ATTACHMENT A
EXISTING TECHNICAL SPECIFICATION
TABLE 3.3.1-1
SAN ONOFRE UNIT 2

ATTACHMENT C

SAN ONOFRE UNIT 2

**PROPOSED SAFETY ANALYSIS REPORT TEXT
SAN ONOFRE UNITS 2 & 3**

SAN ONOFRE NUCLEAR GENERATING STATION Units 2 & 3
CEA WITHDRAWAL FROM SUBCRITICAL RCS TEMPERATURES vs. TIME
Figure 15.4-4

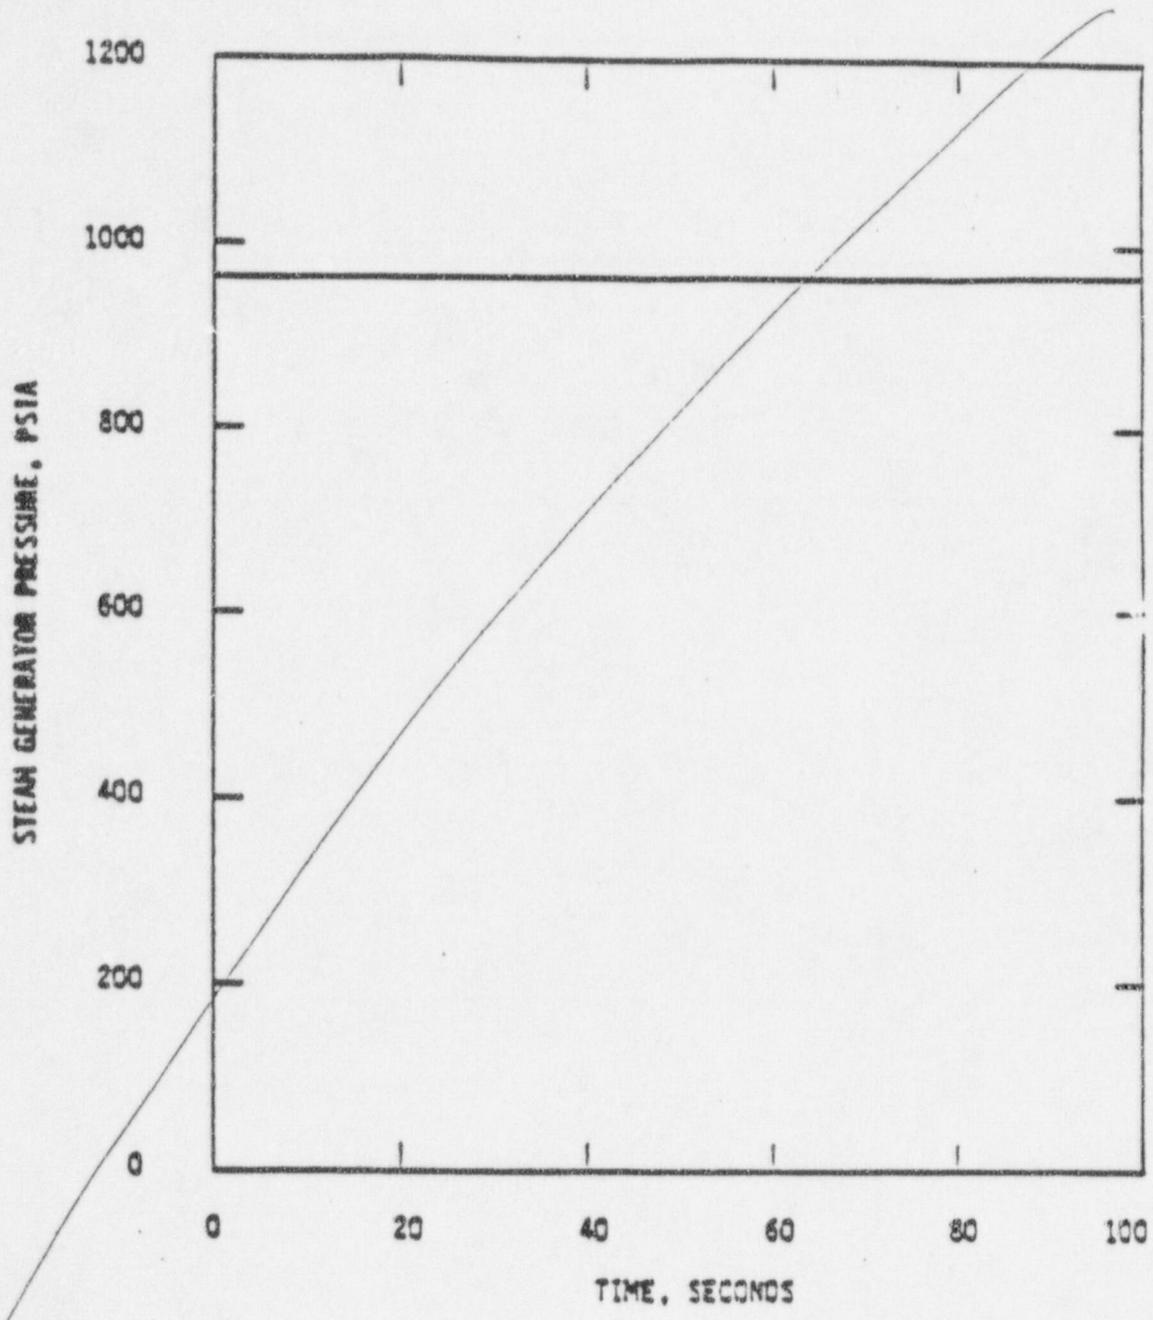
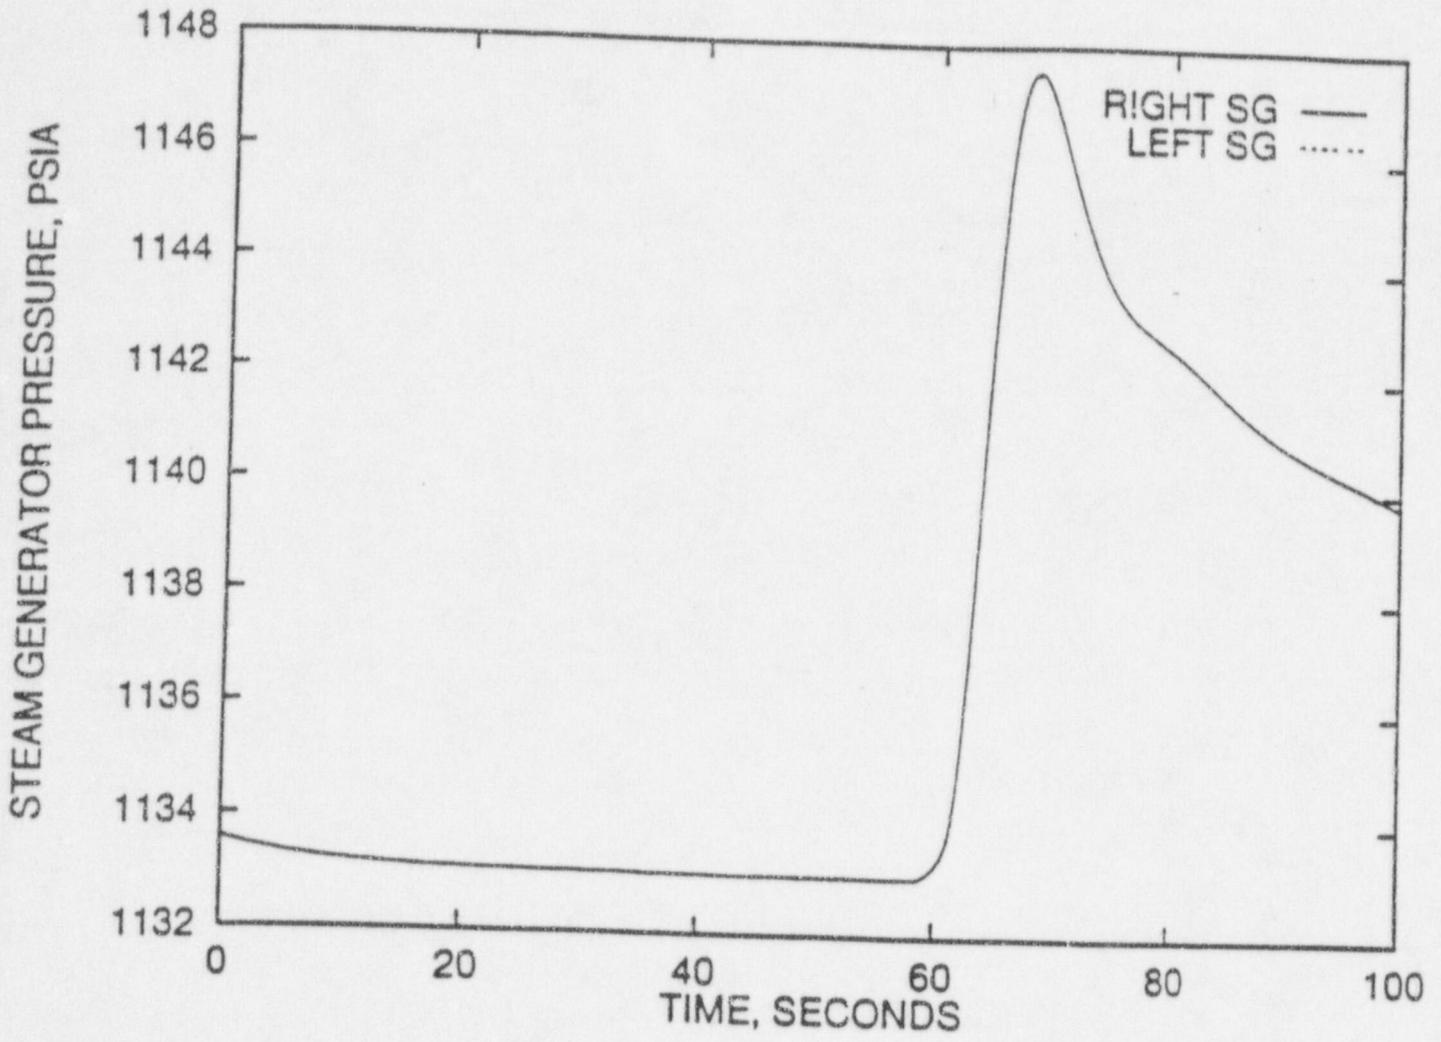
Replac

Updated

SAN ONOFRE NUCLEAR GENERATING STATION UNITS 2 & 3
CEA WITHDRAWAL FROM SUBCRITICAL RCS TEMPERATURES vs TIME
FIGURE 15.4-4

SAN ONOFRE NUCLEAR GENERATING STATION Units 2 & 3
CEA WITHDRAWAL FROM SUBCRITICAL STEAM GENERATOR PRESSURE vs. TIME
Figure 15.4-5

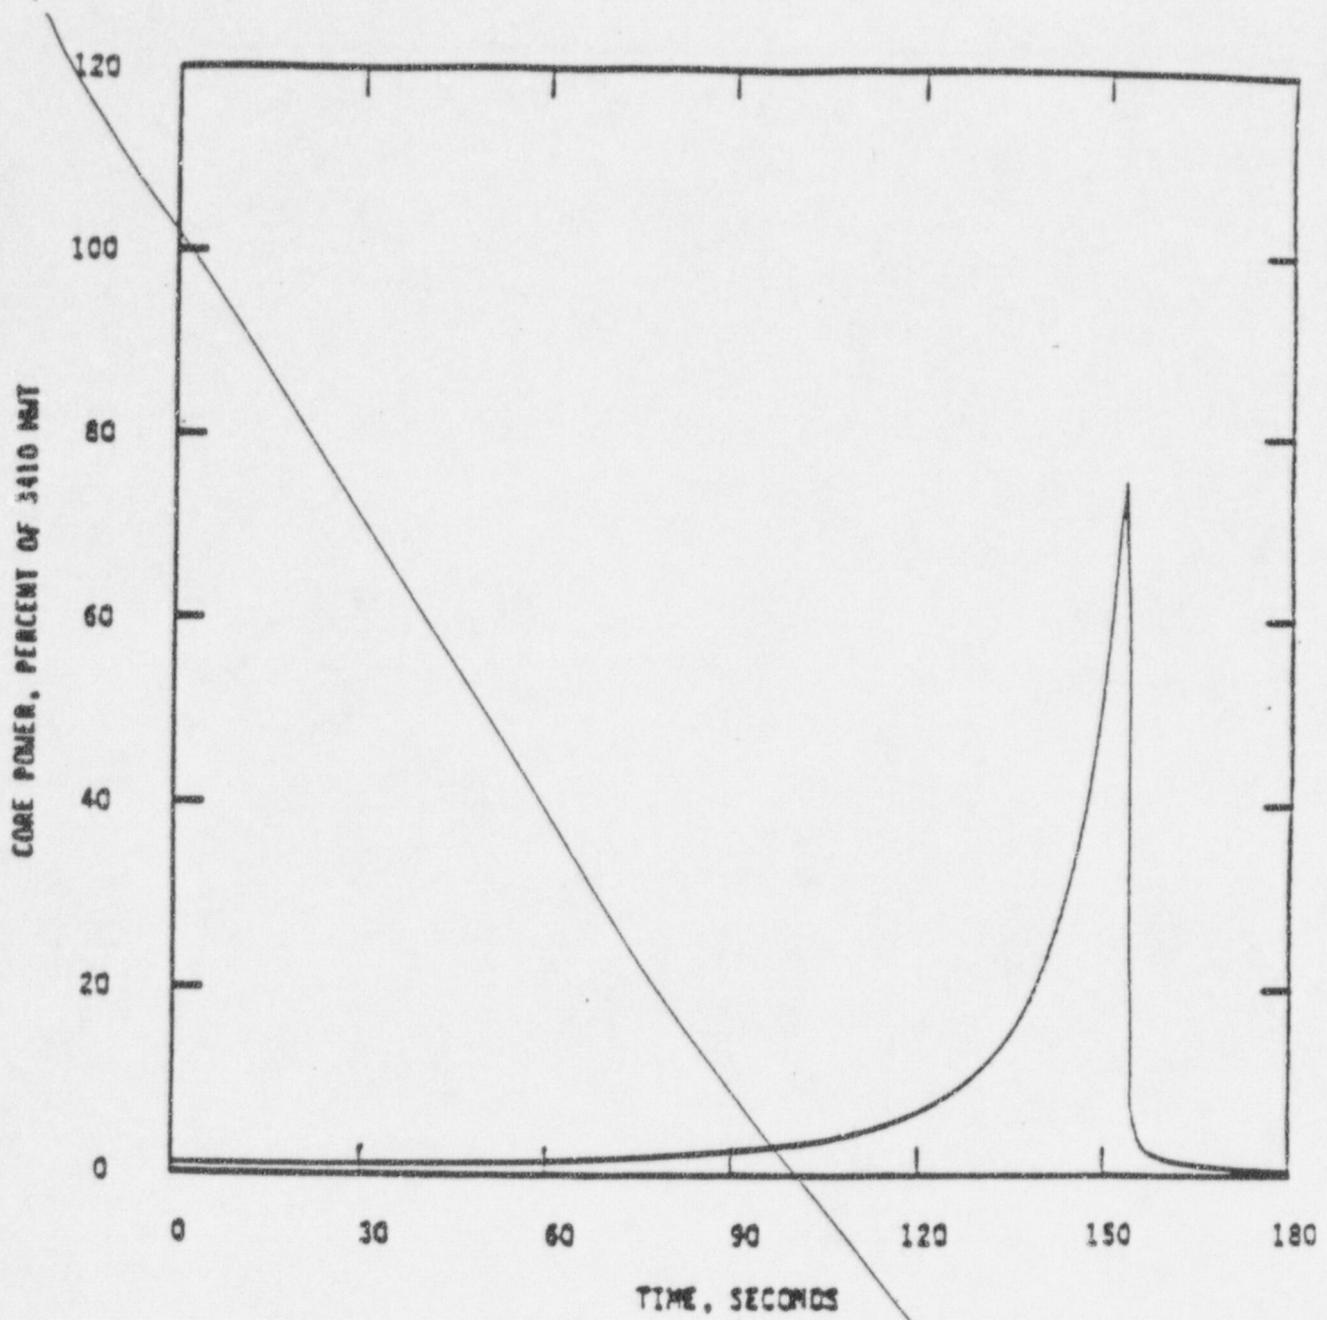
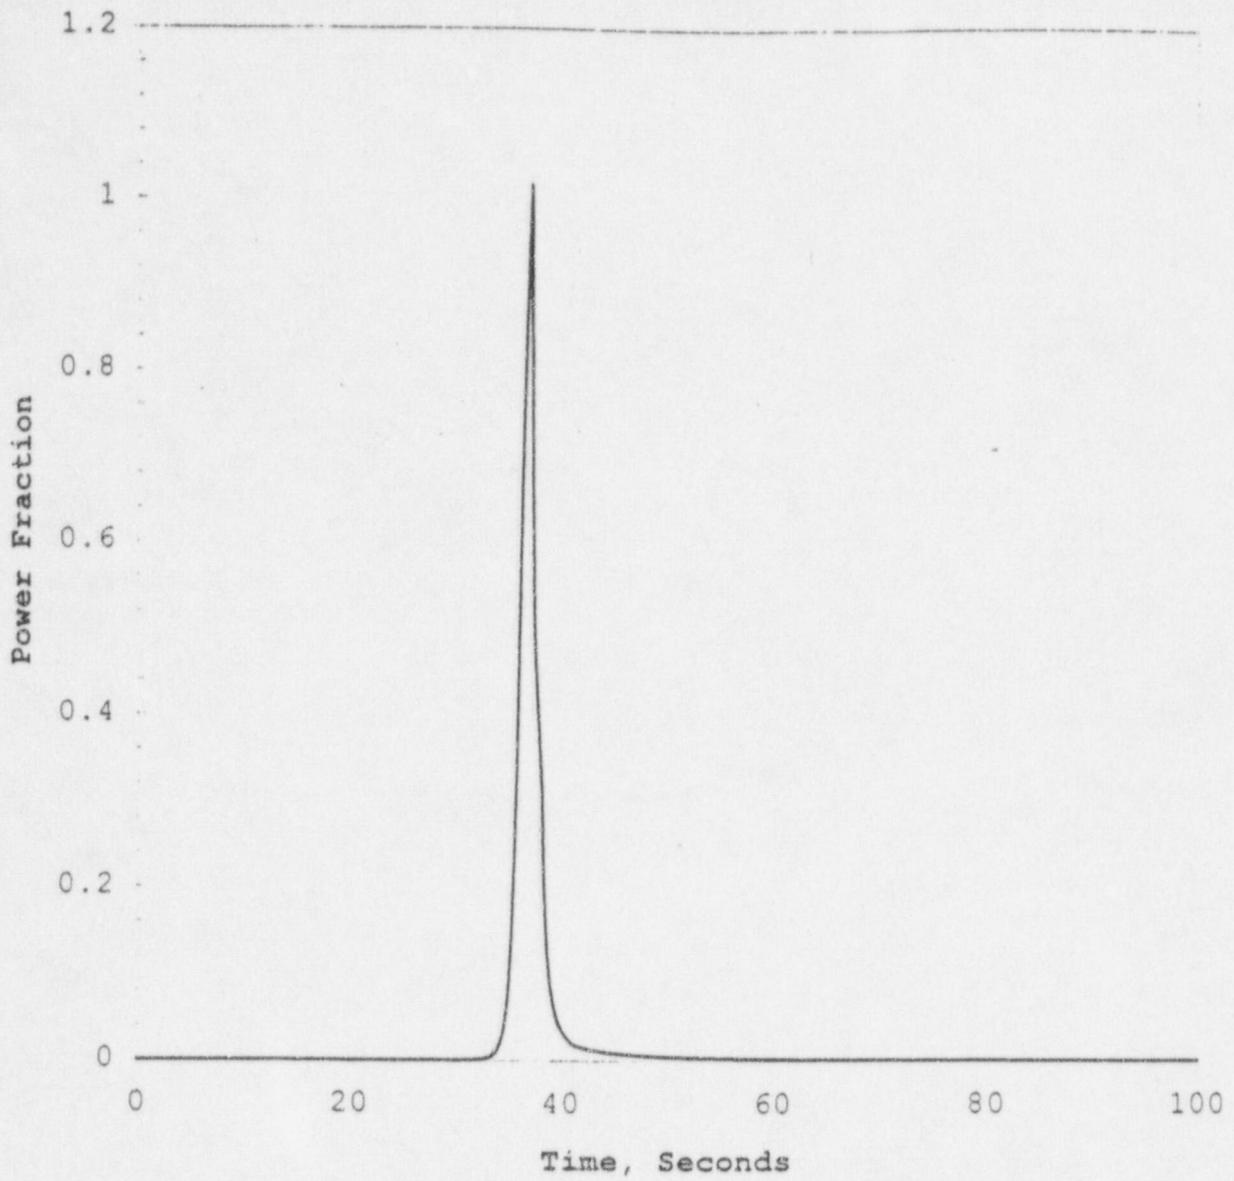
Replace

Updated

SAN ONOFRE NUCLEAR GENERATING STATION UNITS 2 & 3
CEA WITHDRAWAL FROM SUBCRITICAL STEAM GENERATOR PRESSURE vs TIME
FIGURE 15.4-5

SAN JOSE NUCLEAR GENERATING STATION Units 2 & 3
CEA WITHDRAWAL AT LOW POWER CORE POWER vs. TIME
Figure 15.4-6

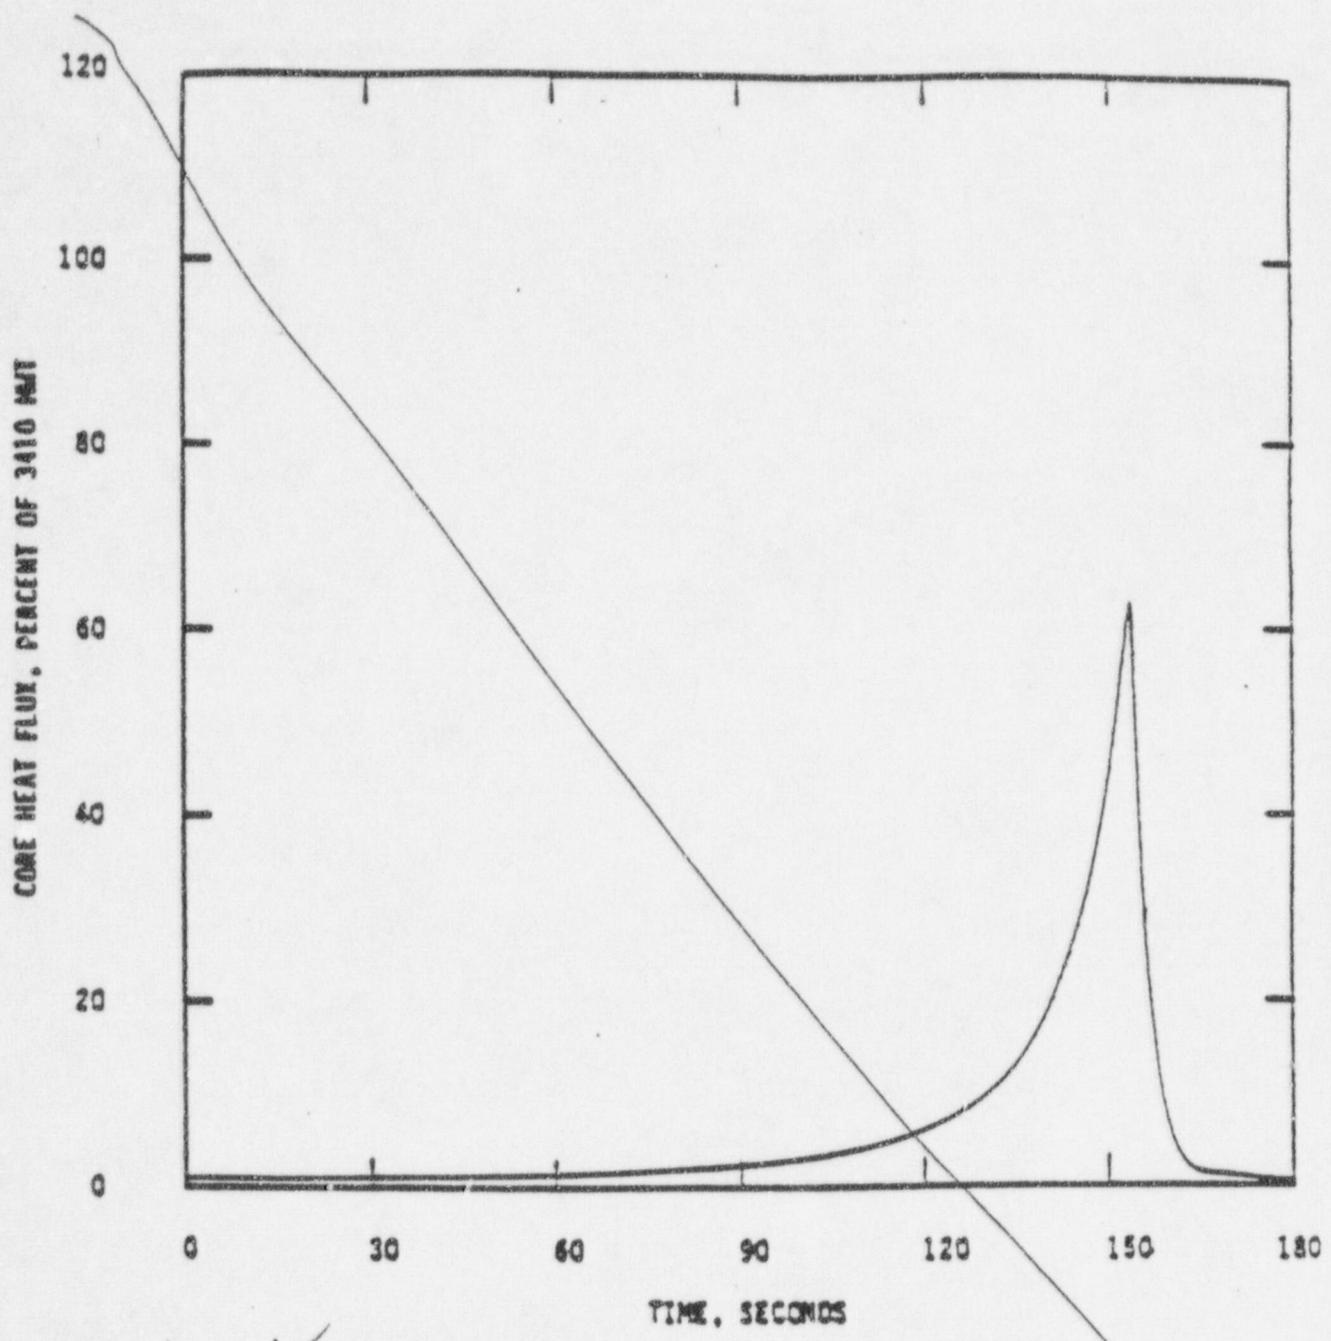
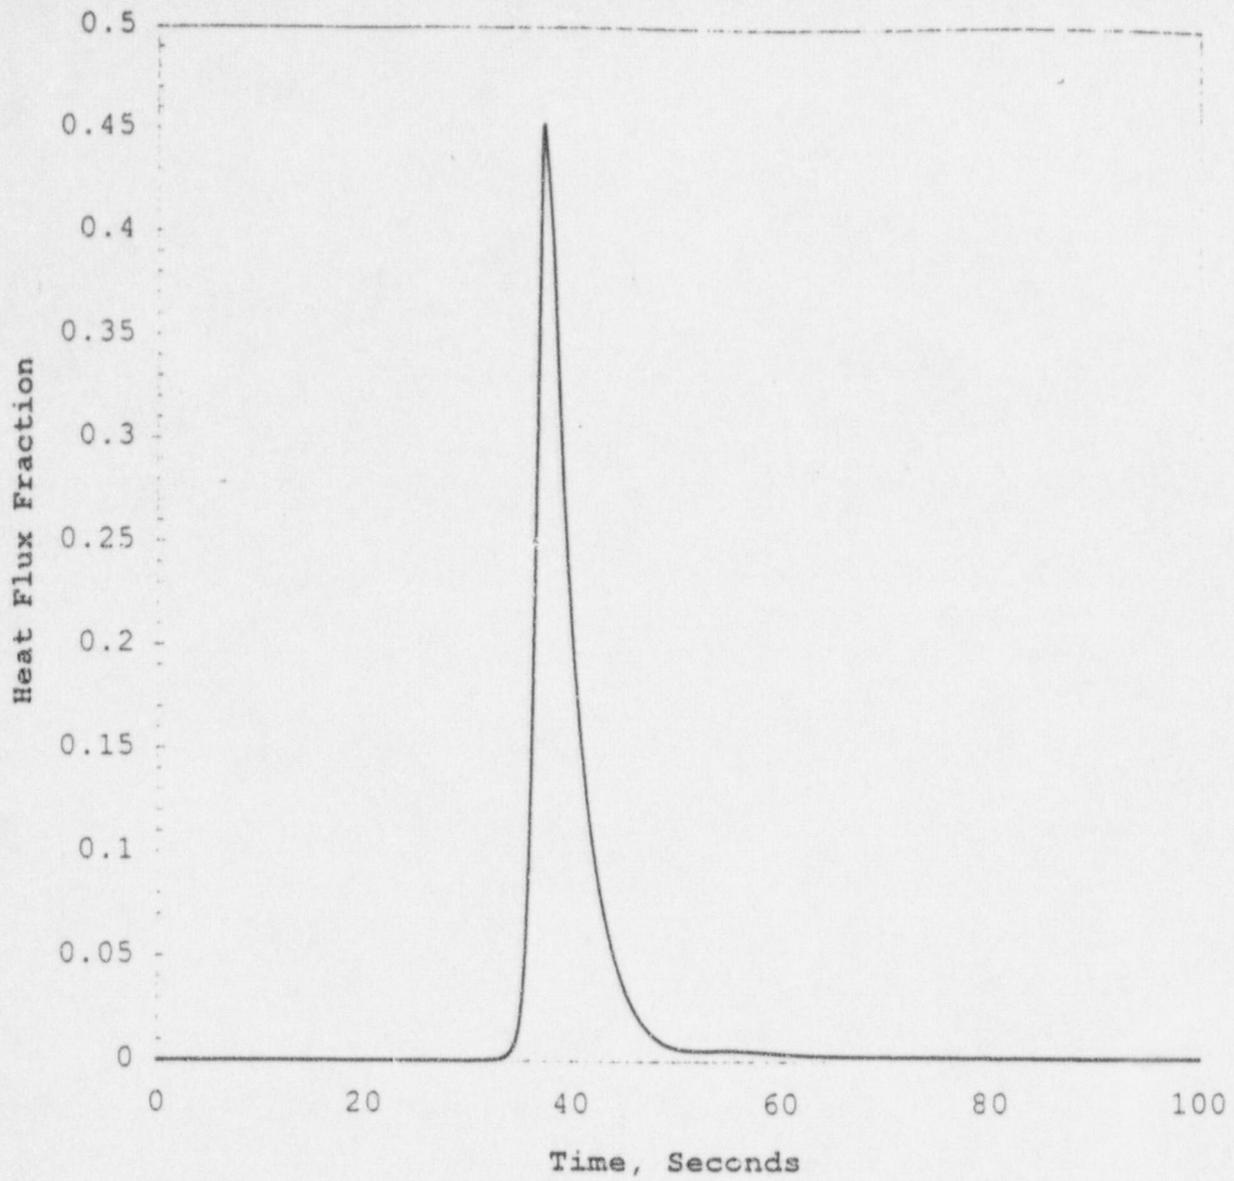
Replace

Updated

SAN ONOFRE NUCLEAR GENERATING STATION UNITS 2 & 3
CEA WITHDRAWAL at LOW POWER POWER FRACTION vs TIME
FIGURE 15.4-6
